U.S. Department of Energy  
**Office of River Protection**

04-WTP-268

U.S. DEPARTMENT OF ENERGY (DOE), OFFICE OF RIVER PROTECTION (ORP)  
RESPONSES TO THE DEFENSE NUCLEAR FACILITIES SAFETY BOARD (DNFSB)  
CONCERNS

## **Responses to Issues Raised in July 21, 2004 Defense Nuclear Facilities Safety Board (DNFSB) Letter Regarding Waste Treatment and Immobilization Plant (WTP) Ventilation Systems Design**

# RPP-WTP HLW Vitrification Facility ISRS

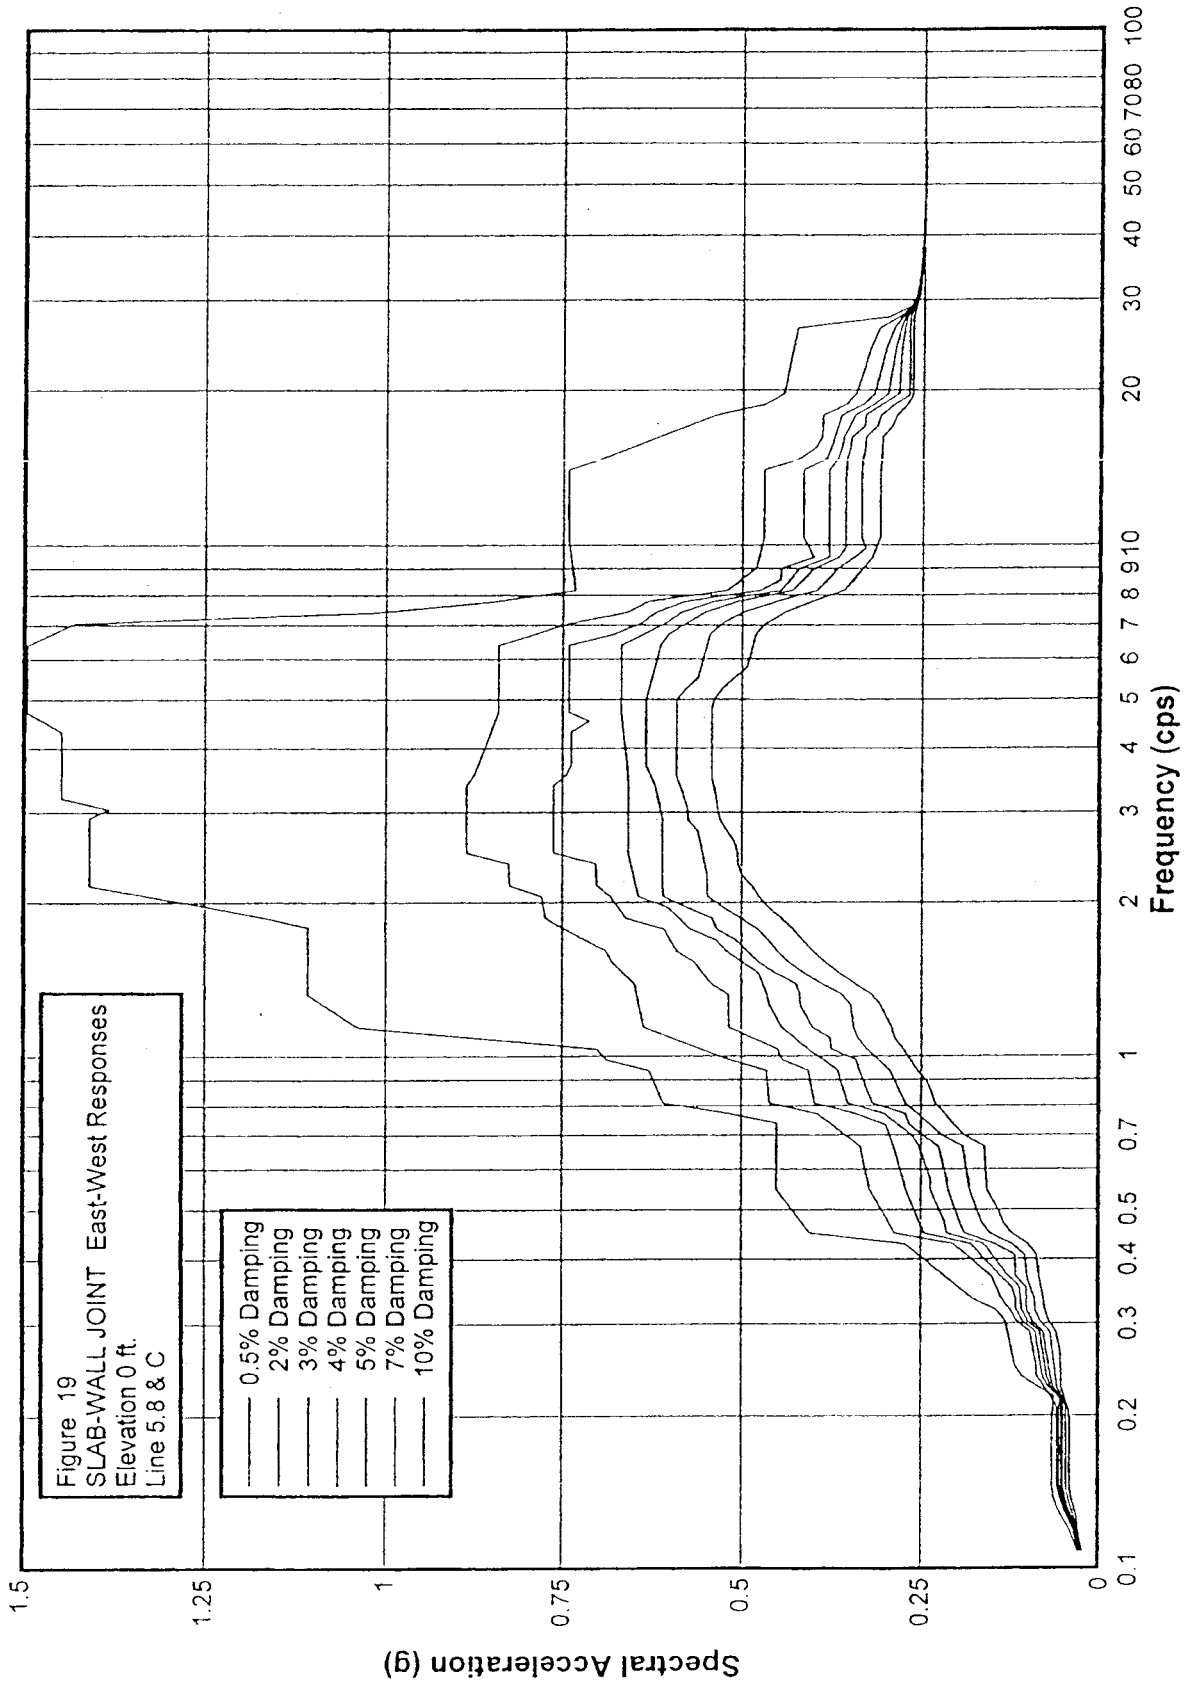
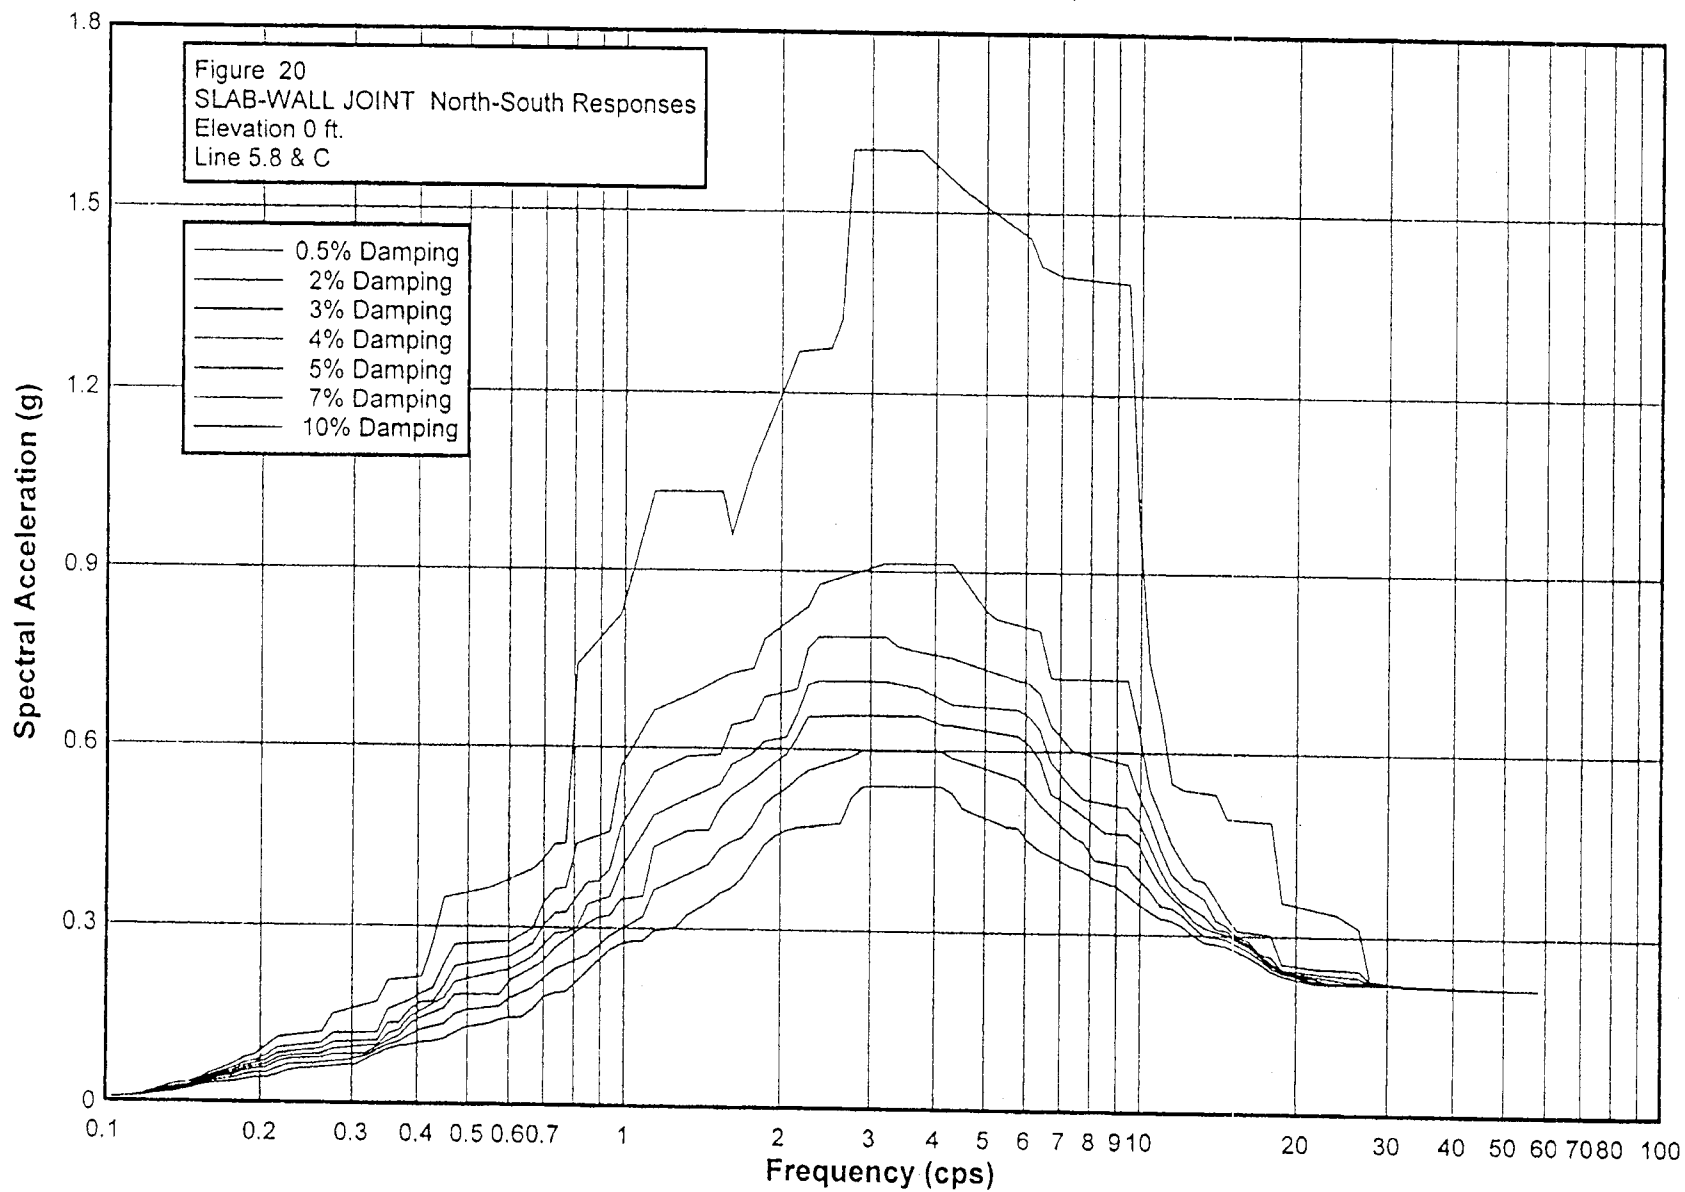
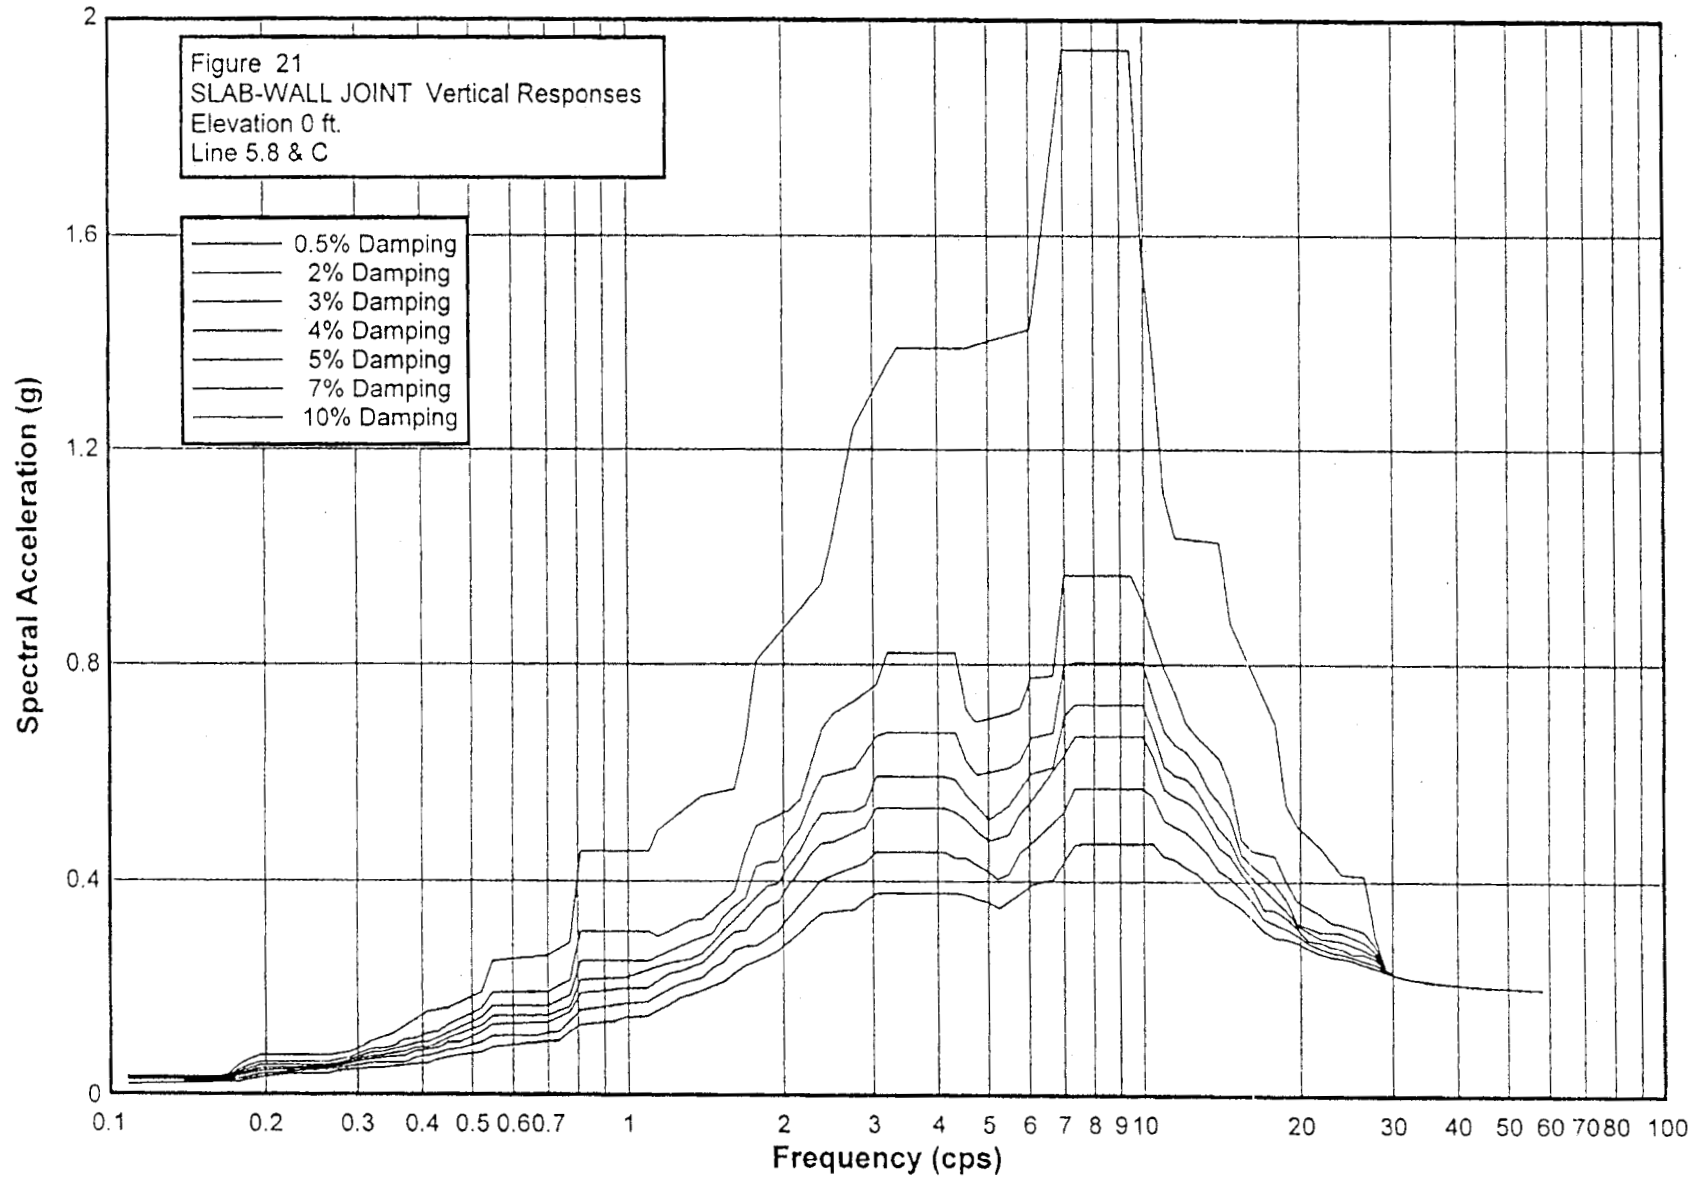
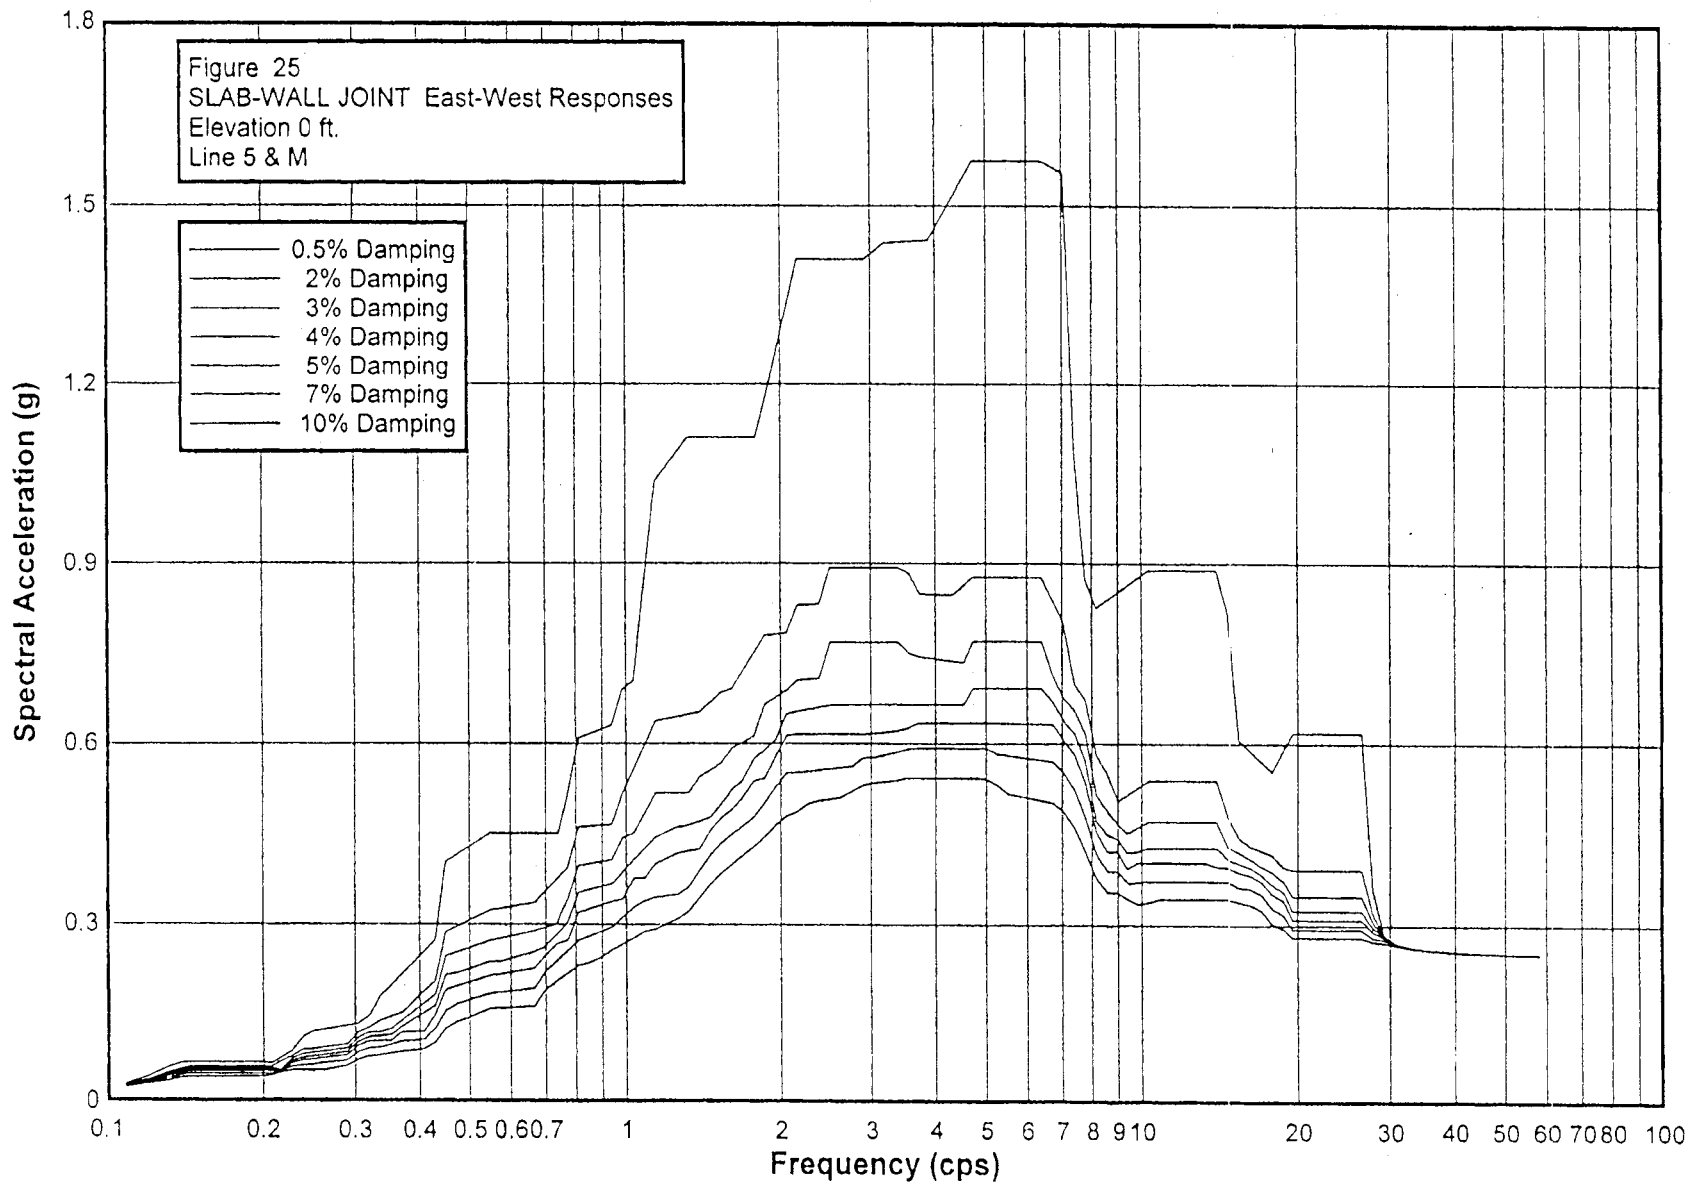
**WTP-04-281-02** The planned ventilation filter housing shaker table tests will use a bounding seismic spectra as input for the shaker table tests. The staff wants to review the bounding data for suitability.

**Response:** The WTP Project will not use bounding data for the PT and HLW facilities. The specific In-Structure Response Spectra (ISRS) curves for each facility will be used and separate testing for each facility will be conducted. The applicable curves, by elevation and column line, for the Remote Change HEPA Filter housings will be used which shows the expected frequencies and accelerations in the north/south, east/west, and vertical directions. The reason for applying the ISRS curves specific to each building and not using bounding data is as follows:

The Remote Change HEPA Filter Housings in the PT and HLW buildings will require separate testing for the following reasons:

- a) The housings are supported by steel platforms. Since the platforms are not rigid, they need to be simulated for testing. The platform configurations are different. Therefore, their simulations would be different, requiring separate testing.
- b) ISRS for PT and HLW buildings are different.
- c) It is likely that the external loads on the housings, e.g., connected ducts, in PT could be different from those in HLW.

Enclosed are the ISRS curves applicable to the Remote Change HEPA Filter housings in the HLW and PTF facilities.†
